**FILE REF.:** CDRC CASE # V/ZA/S 10-5352 Rio Santa Fe Business Park

Peña Blanca Partnership, Applicant, Jim Siebert, Agent, requests a Master Plan Zoning Amendment to an existing Zoning approval, Preliminary and Final Plat and Development Plan approval to create four (4) commercial lots on a 31.44 ± acre parcel for Commercial/Industrial use. The Applicant also requests a variance to allow a Cul-De-Sac (Dead End Road) to exceed 500 feet in length. The property is located at 54 Colony Drive, North West of N.M. 599, North of Paseo De River, within Section 10, Township 16 North, Range 8 East, (Commission District 2).

**Reference: Rio Santa Fe Business Park Preliminary/ Final Plat, Final Development Plan, & Master Plan Amendment**

Re: CDRC Case # MPA/PP/FP/FDP 10-5352 Rio Santa Fe Business Park- Master Plan, Preliminary and Final Plat T16N, R8E, Sec 2, 3 and 10.

## TERRAIN MANAGEMENT PLAN GRADING AND DRAINAGE PLAN

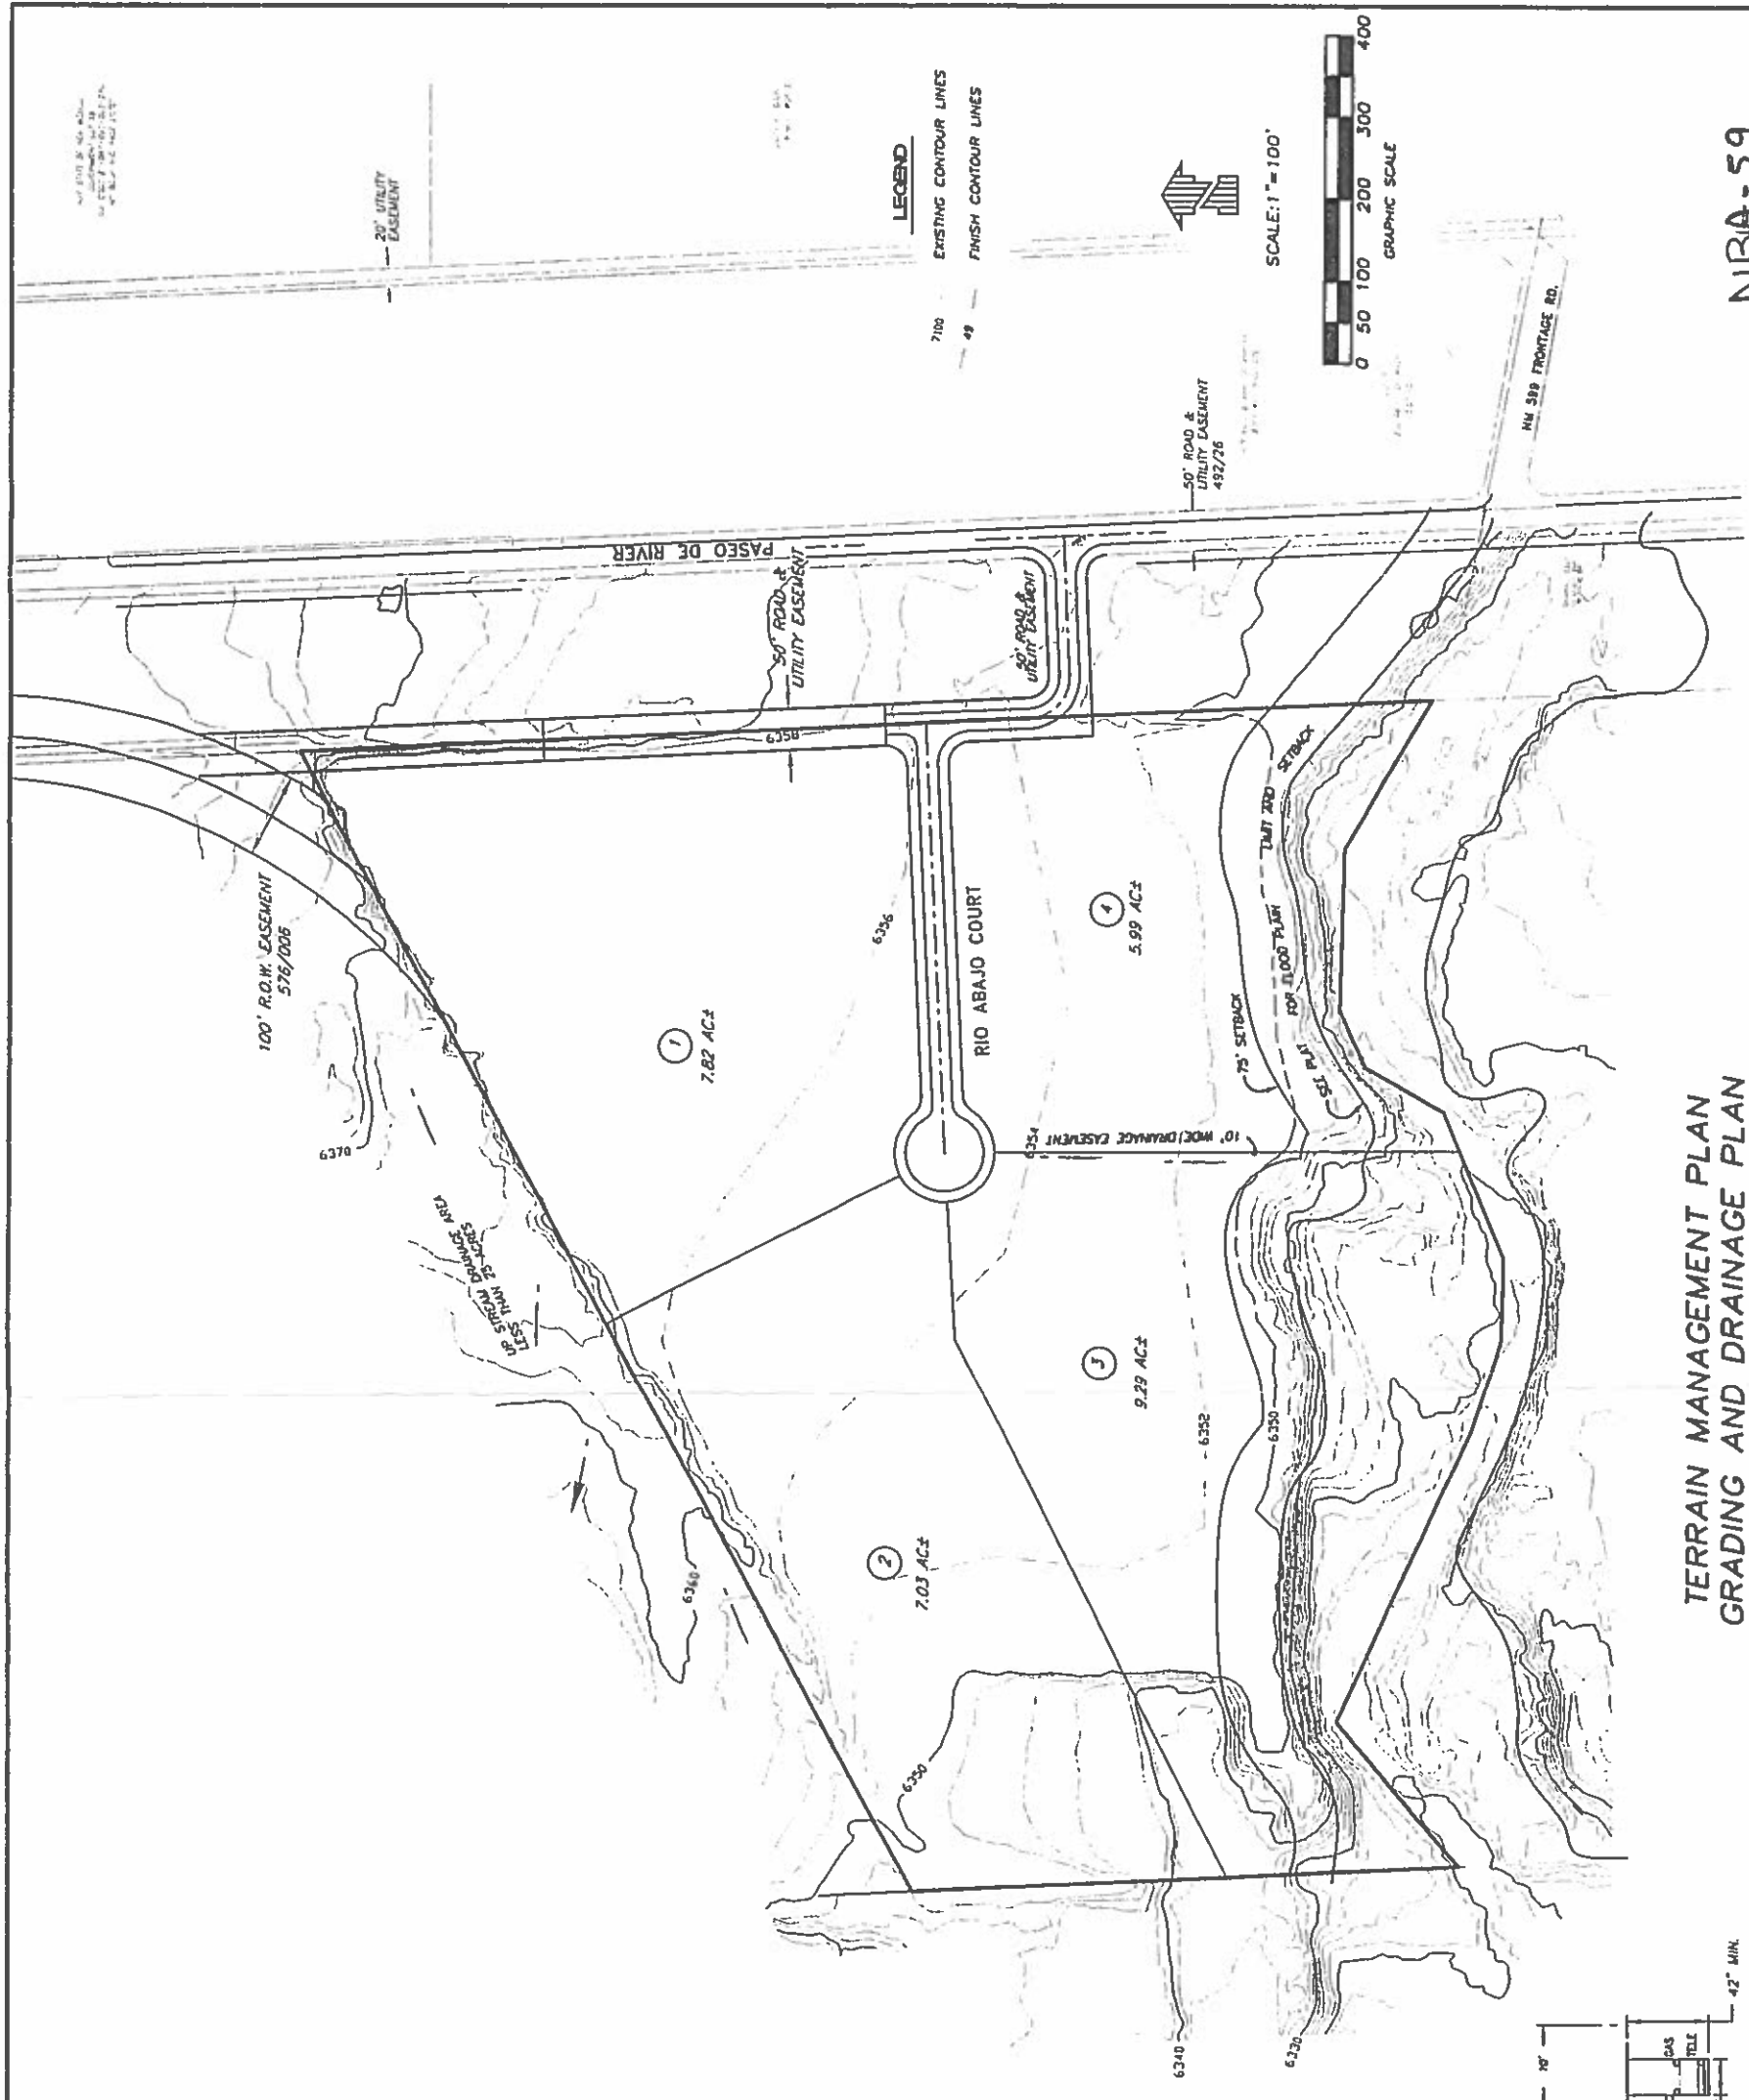
Each lot owner is required to detain the runoff on their lot including a prorated share of the runoff from the road. Engineering calculations on the typical estimated runoff and required ponding on the lot have been prepared by a Professional Engineer and are included in the plan set for the Subdivision.

The estimated detention pond requirements for each lot are provided on the terrain management sheet for the Subdivision.
